This study represents a good first step in attempts to characterize the AERIS instrument performance for methane and ethane concentration measurements. The ultimate goal of this study is to assess the suitability for a suite of 4 AERIS instruments to be employed in a regional tower-based flux study over the Denver-Julesburg Basin (DJB) as shown in Fig. 2. **This reviewer recommends publication of the methane results after major revisions, as discussed below. The ethane results, however, are more problematic and will require additional data and validations. Instead I would bill the AERIS ethane measurements as a work in progress requiring further validation.**

Figure Caption: Absorbance simulations for a 15 m pathlength, sampling cell pressure of 240 mb and a temperature of 42°C. HITRAN 2020 absorption parameters of methane and water were employed in these simulations with Harrison ethane absorption parameters (not incorrect HITRAN values).

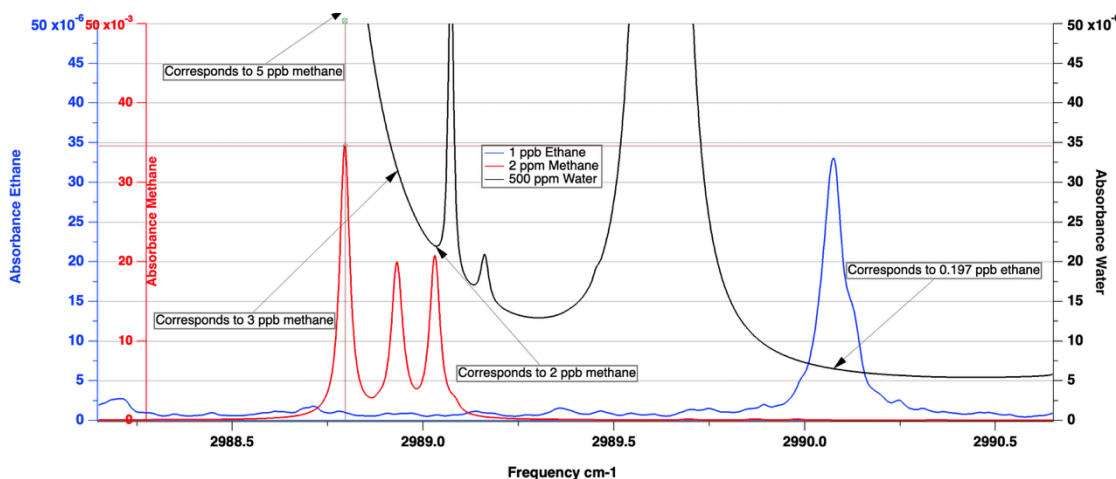
The above simulations reveal a number of important features. First the absorbance ($-\ln$ transmission) for 1 ppb ethane is approximately 3 orders of magnitude weaker than ambient methane levels around 2 ppm. Secondly, the water vapor correction will dramatically be affected by the Nafion scrubber performance. Even small changes in this performance will adversely affect the measurement accuracy. Thirdly, as can be seen, the water vapor tail around the ethane line is relatively flat but the features around the 3 methane lines are steeply sloping. Hence, the water-vapor interference on methane will be more dramatic than ethane, as borne out by your Fig 3 plots. **This reviewer thus strongly recommends that water vapor concentrations need to be retrieved along with the methane and ethane values to assess in real time the Nafion scrubber performance in order to effect corrections. To the degree possible, this reviewer also recommends a close examination of the software fitting algorithms and parameters**

employed. Specifically, are the methane results based on one, two, or all three lines, and what are the absorption parameters employed (line positions, absorption and broadening coefficients, etc.)?
